PARLIAMENTARY STANDING COMMITTEE ON
PUBLIC WORKS.

WHARFAGE FACILITIES, DARWIN.

WHARFAGE FACILITIES, DARWIN.

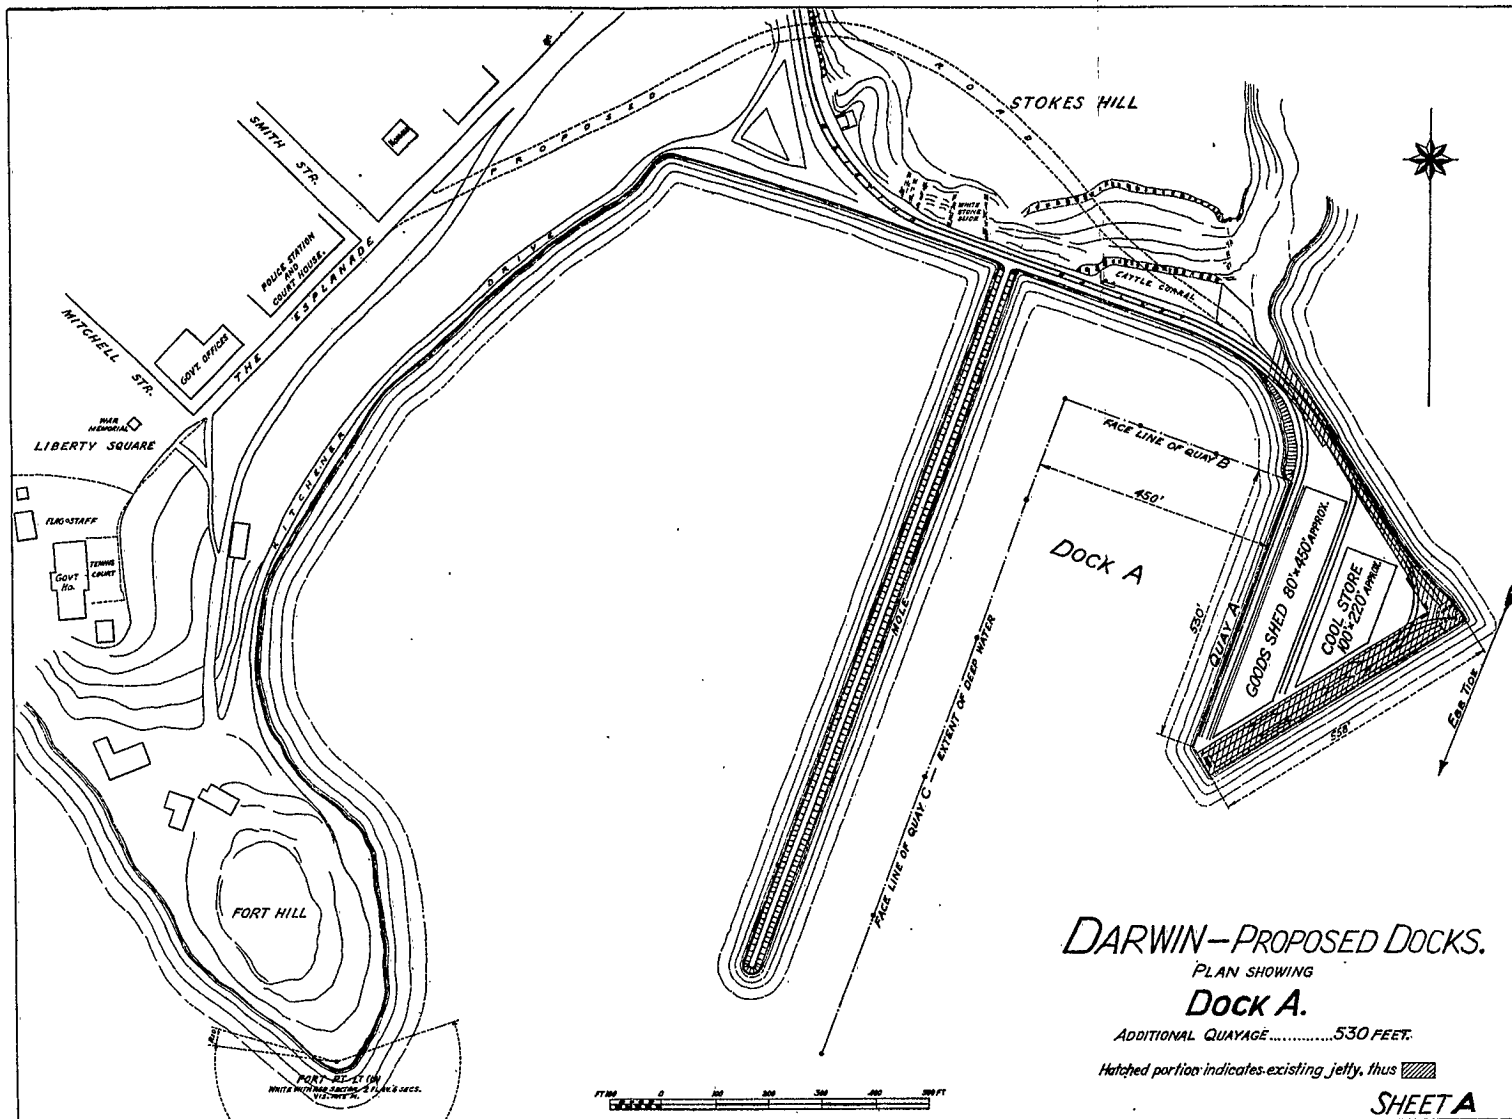
- (iv) The stability of the wall proposed by Mr. Ramsbotham, in my judgment, is open to question. The question of stability has been carefully investigated by the recognized methods, and in the light of experience, and under water-borne conditions, such a wall would not, in my opinion, be stable. I consider that the width should be increased by 3 ft. 6 in., or 16.4 per cent., to obtain a section of wall that would be stable under water-borne conditions.

- (3) Stability of wall is open to question.

In my first proposals for a wall, I rather made a point of having two cutting edges under the base of the wall, as I wished to ensure a good grip of the ground, and prevent any tendency for the wall to slip when filling was deposited behind. After further very careful consideration, I came to the conclusion that it would be wise to omit them, as the cutting edges, as in the event of hard rock being encountered in one place, and not in others, difficulties might arise. Any tendency of the wall to slip will be dealt with more satisfactorily by a modification suggested by my partner, Professor T. R. Wilton, M.A., M.Inst.C.E., that is, to provide a space in the centre of each pocket, or box, for driving, say, a 4 in. by 4 in. steel grip, or pile, into the ground, after the caisson has taken up its correct position, then concreting in the extra thickness of floor already allowed for in my design. This is a very simple proposal, and should be adopted. It will not only keep the caisson in its position in the early stages, but will subsequently prevent any tendency for the wall to slide on its base when the filling is tipped behind the wall. (Vide appendix for all data.)

Factor of safety, 2.979.

Eccentricity of resultant thrust 3.542 feet.

Average intensity of pressure per square foot on foundation, 3,068 tons.

Maximum intensity of pressure per square foot on foundation, 5,578 tons.

With regard to the two latter items, sand was provided for in the design, and any assistance from the schist in front of the toe of the wall was disregarded.

SHEET A

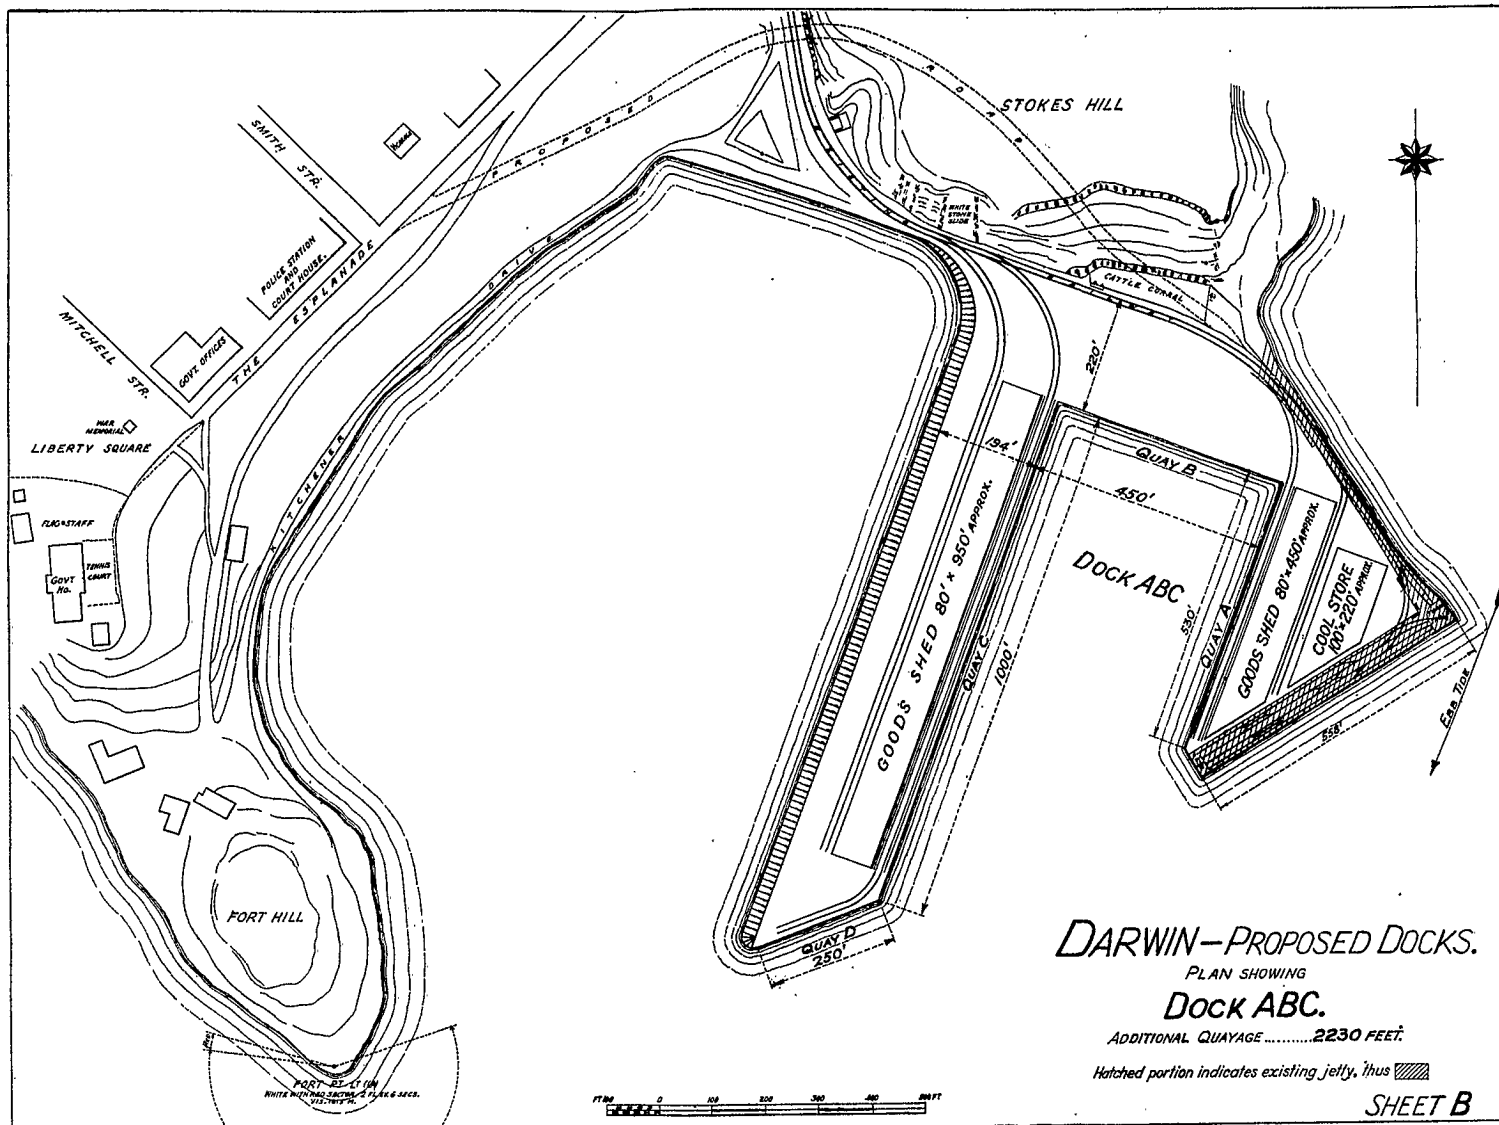
13. The first stage of development provides for the construction of a solid wall from the toe of the L in a north-easterly direction to the shore, the resultant triangle to be filled in solid with spoil from the adjacent Stokes Hill and paved with concrete. This wall gives, in addition to the 575 feet provided by the existing jetty, Quay A, with wharfage accommodation in sheltered water to the extent of 530 feet, as indicated on Sheet A attached.

PLAN E.

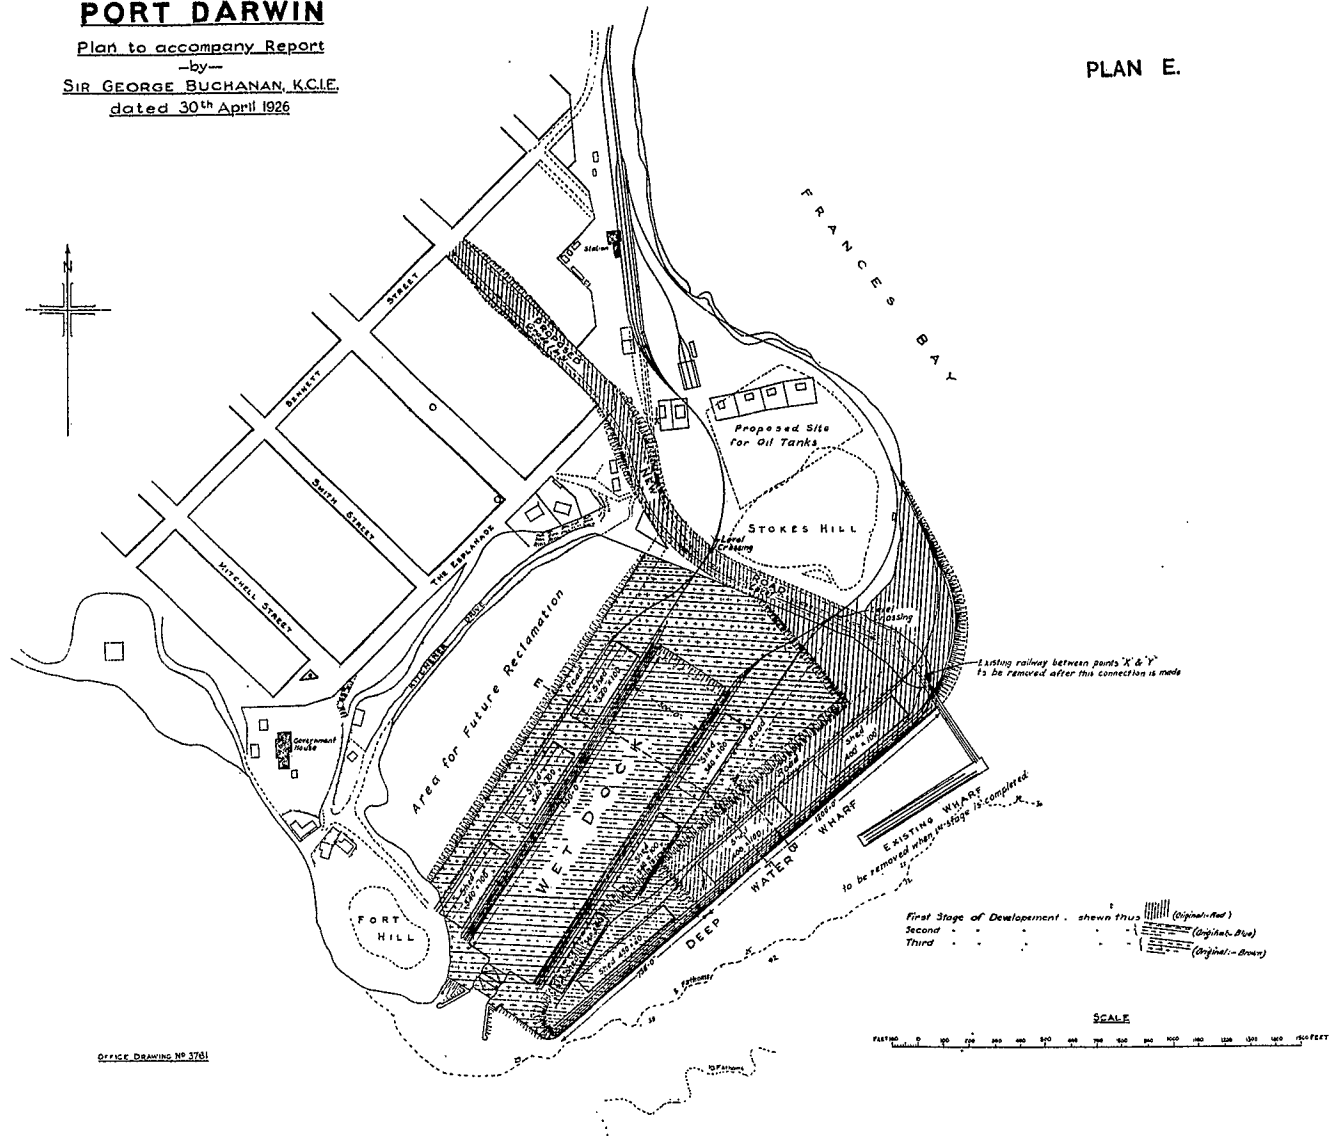
The outline and position of the dock is generally similar to the tidal dock of Scheme A, but it is provided with two pairs of entrance gates to retain the water. The entrance to the dock is situated under the south-east corner of Fort Hill as shown on plan E.
